POINT VICENTE INTERPRETIVE
 CENTER EXPANSION
 31400 Point Vicente Avenue West
 Rancho Palos Verdes, CA

REVISED EXHIBIT
 AREA PLAN

DRAWN	MG
CHECKED	RY
DATE	5/21/2005
SCALE	(as noted)
JOB NO.	95-120
SHEET	A-14

PUBLIC EXPANSION Building Plans
 Revised Exhibit A-14 May 21, 2005

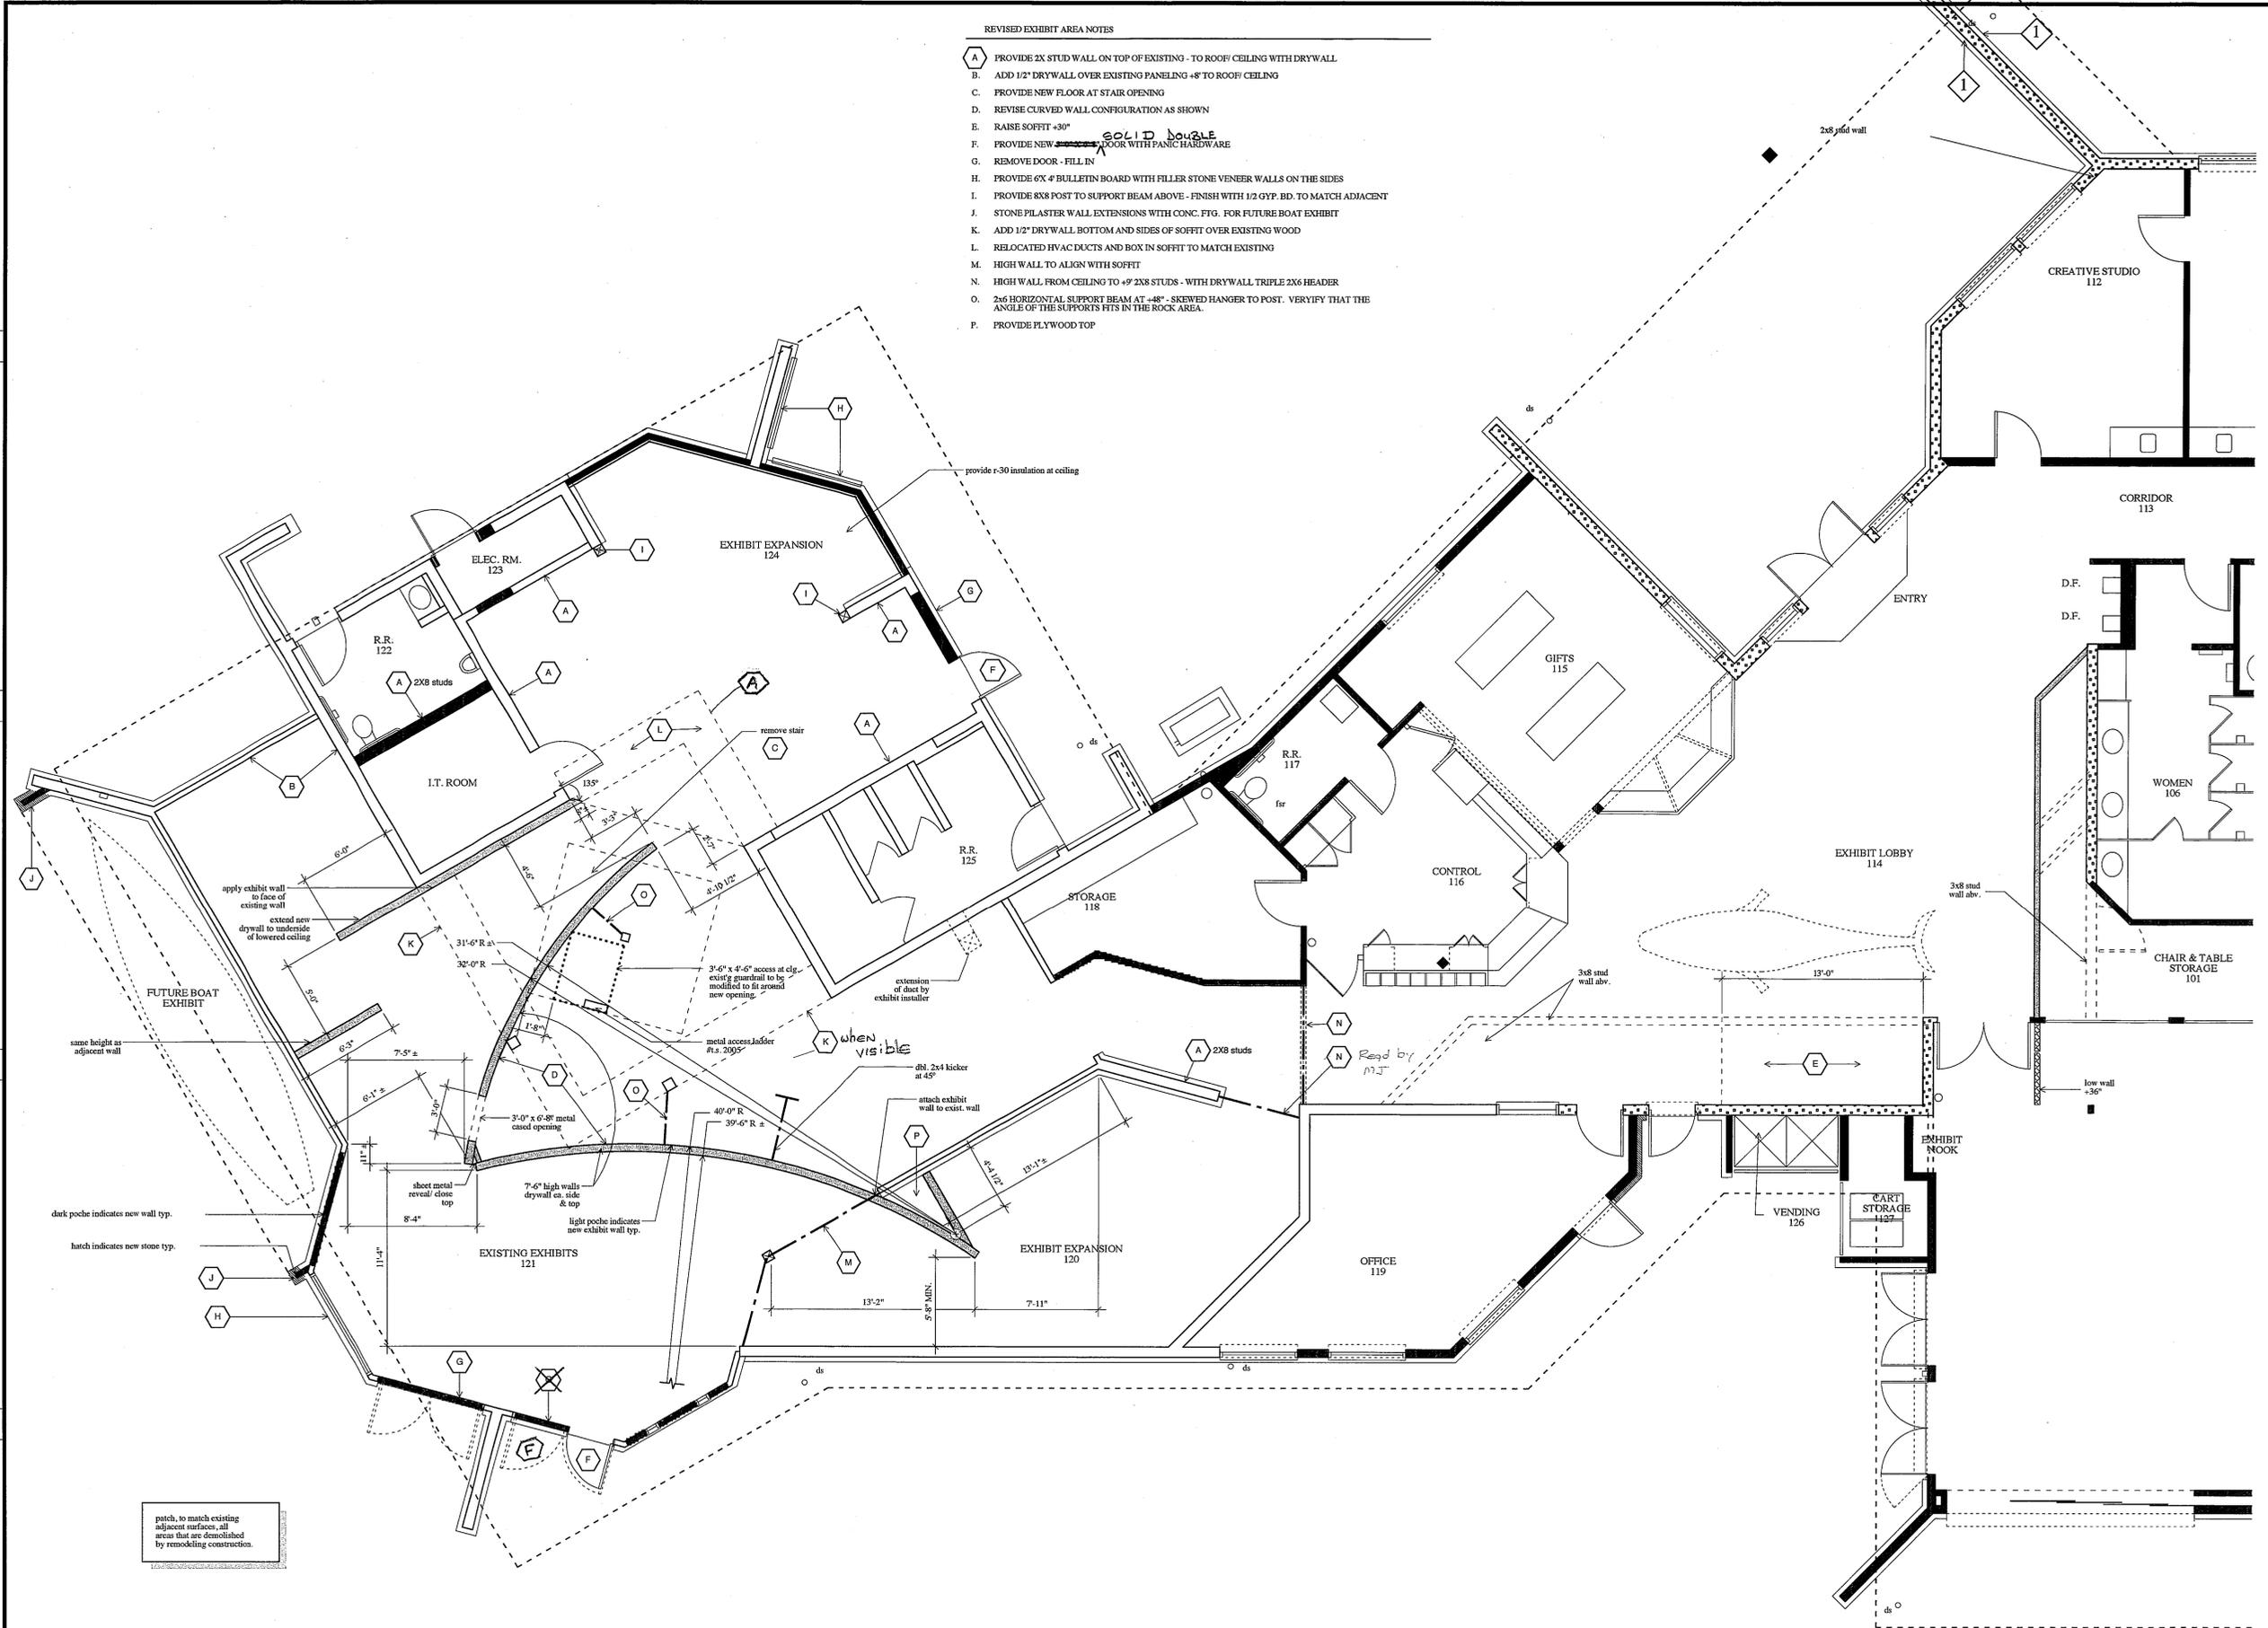
- A. PROVIDE 2X STUD WALL ON TOP OF EXISTING - TO ROOF/CEILING WITH DRYWALL
- B. ADD 1/2" DRYWALL OVER EXISTING PANELING -8" TO ROOF/CEILING
- C. PROVIDE NEW FLOOR AT STAIR OPENING

- D. REVISE CURVED WALL CONFIGURATION AS SHOWN
- E. RAISE SOFFIT +30"
- F. PROVIDE NEW ~~DRYWALL~~ **SOLID DOOR** FLOOR WITH PANIC HARDWARE
- G. REMOVE DOOR - FILL IN

- H. PROVIDE 6X 4 BULLETIN BOARD WITH FILLER STONE VENEER WALLS ON THE SIDES
- I. PROVIDE 8X8 POST TO SUPPORT BEAM ABOVE - FINISH WITH 1/2 GYP. BD. TO MATCH ADJACENT

- J. STONE PLASTER WALL EXTENSIONS WITH CONC. FTG. FOR FUTURE BOAT EXHIBIT
- K. ADD 1/2" DRYWALL BOTTOM AND SIDES OF SOFFIT OVER EXISTING WOOD
- L. RELOCATED HVAC DUCTS AND BOX IN SOFFIT TO MATCH EXISTING

- M. HIGH WALL TO ALIGN WITH SOFFIT
- N. HIGH WALL FROM CEILING TO +9' 2X8 STUDS - WITH DRYWALL TRIPLE 2X6 HEADER
- O. 2x6 HORIZONTAL SUPPORT BEAM AT +48" - SKEWED HANGER TO POST. VERIFY THAT THE ANGLE OF THE SUPPORTS FITS IN THE ROCK AREA.

- P. PROVIDE PLYWOOD TOP
